IEEE802.3bt  
LLDP adhoc

Meeting #2: Rev 002C, Tuesday June 20, 2017

# LLDP concept review as agreed in D2.5 – Updated per the current text Proposal for a change marked in RED.

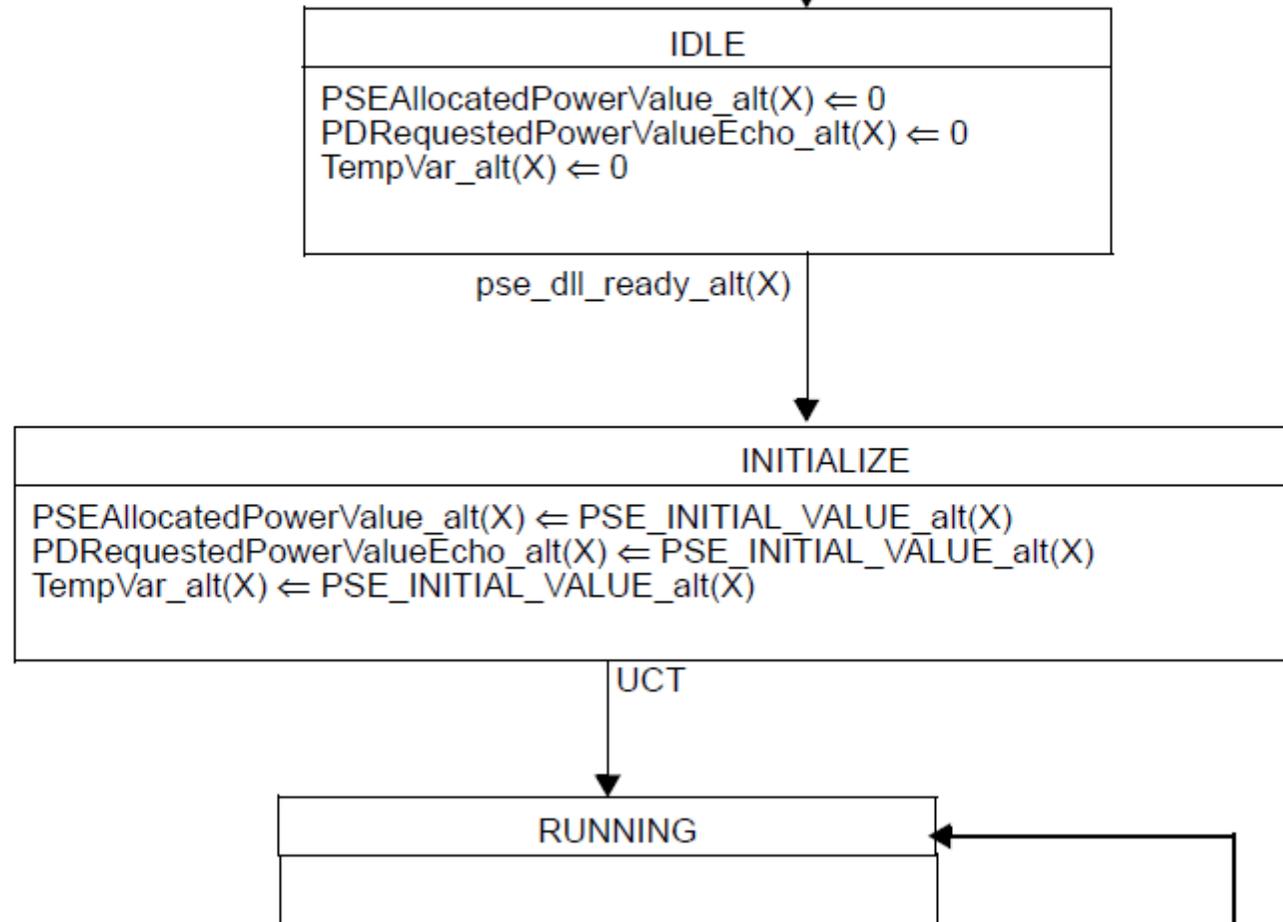
PSE	Use the following PSE fields	PD	Use the following PD fields
4-pair	PSE allocated power PSE allocated power Alternative (X)=0	Single-Signature. Type 1, Type 2	PD requested power PD requested power Mode (X)=0
Type 3 or 4. Operating over 2-pair.	<ul style="list-style-type: none"> <li>PSE allocated power</li> <li>PSE allocated power Alternative (X). <i>Fill in 0 in the inactive field of PSE allocated power Alternative (X).</i></li> <li>PSE allocated power = A+ B (**) <i>(or PSE allocated power =PSE allocated power Alt (X) where X is the active Alternative)</i></li> </ul>	Dual-signature	<ul style="list-style-type: none"> <li><i>Fill in 0 in the inactive field of PD requested power Mode (X).</i> <i>(Delete to resolve #279)</i></li> <li>PD requested power Mode A and B.</li> <li>PD requested power = A+B (**) <i>(To replace with Y=mode(X) where X is the active mode)</i></li> </ul>
Type 1 or 2. Operating over 2-pair.	<ul style="list-style-type: none"> <li>PSE allocated power</li> <li>(*May) PSE allocated power = PSE allocated power Alternative A + B (**) <i>(Lennart suggest to set to zero. Yair: If PSE allowed to use this fields, it is better to use PSE allocated power =PSE allocated power Alt (X) where X is the active Alternative))</i></li> </ul>	Dual-signature	<ul style="list-style-type: none"> <li><i>Fill in 0 in the inactive field of PD requested power Mode (X).</i> <i>(Delete to resolve #279)</i></li> <li>PD requested power Mode A and B.</li> <li>PD requested power = A+B (**) <i>(To replace with Y=mode(X) where X is the active mode)</i></li> <li>PD requested power Mode B (**)</li> </ul>

Operating over 4-pair.	<ul style="list-style-type: none"> <li>PSE allocated power Alternative A and B</li> <li>PSE allocated power = PSE allocated power Alternative A + PSE allocated power Alternative B <i>(Lennart suggest to set to zero)</i></li> </ul>	Dual-signature	<ul style="list-style-type: none"> <li>PD requested power Mode A and B</li> <li>PD requested power = PD requested power Mode A + PD requested power Mode B <i>(Lennart suggest to set to zero)</i></li> </ul>

(\*\*) Why we need Y=A+B, see Annex and see alternative solutions i.e. PSE allocated power =

PSE allocated power Alternative X and PD requested power = PD requested power Mode (X) when X is the active pairs.

Comment #297 D2.4 (Page 75 line 12 in D2.5) - Figure 145-44  
 Proposal for a change marked in RED.

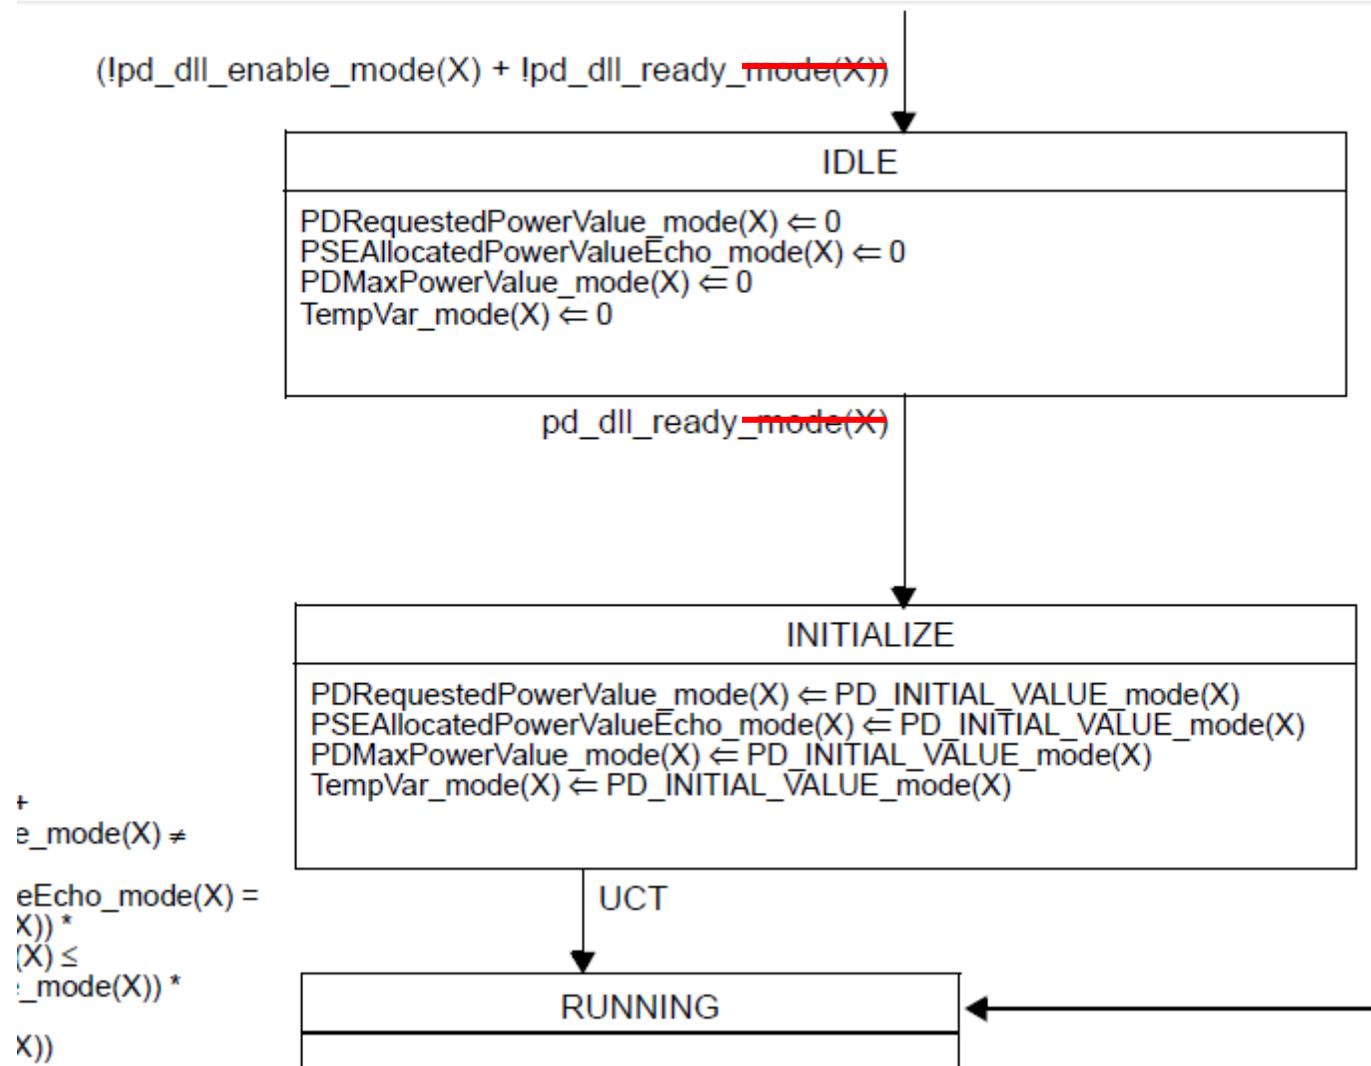
# Comment #297 D2.4 (Page 75 line 12 in D2.5) Figure 145-43

$(!pse\_dll\_enable\_alt(X) + !pse\_dll\_ready\_alt(X)) * (sig\_type = dual)$

- We have the information of total available power in the field “PSE maximum available power” in 79.3.2.6e. This resolve argument #2 in Annex A.
- To resolve #297, Lennart suggests: In order to request power on the unpowered pairset, see proposed changes in the red text. In addition, the `pd_dll_ready_mode(X)` need to be changed to `pd_dll_ready` to allow progressing to the INITIALIZE state in case PD want power on the unpowered pairset. No changes required in the PSE portion.

- Yair it will work:
  - To change from `pd_dll_ready_mode(X)` to `pd_dll_ready` in the PD state machine.
  - To change “if this mode/Alt is inactive, set to value 0” to “if this Alt is inactive, set to value 0” i.e. keep this requirement only to PSE.

- In Figure 145-44 and Figure 145-45 power control state diagrams when connected to dual-signature PD, we add in D2.3 an IDLE state in order to resolve non active Alternative(X) or no active mode(X) by setting the relevant variables to zero prior going to INITIALIZE state.
  - Figure 145-45: PSEAllocatedPowerValue\_alt(X), PDRequestedPowerValueEcho\_alt(X) and TempVar\_alt(X)
  - Figure 145-46: PDRequestedPowerValue\_mode(X), PSEAllocatedPowerValueEcho\_mode(X), PDMaxPowerValue\_mode(X) and TempVar\_mode(X)

- **Lennart response:** The proposed response to this comment is to adopt:
  - To change from `pd_dll_ready_mode(X)` to `pd_dll_ready` in the PD state machine.
  - To change “if this mode/Alt is inactive, set to value 0” to “if this Alt is inactive, set to value 0” i.e. keep this requirement only to PSE.
- **Group to discuss.**
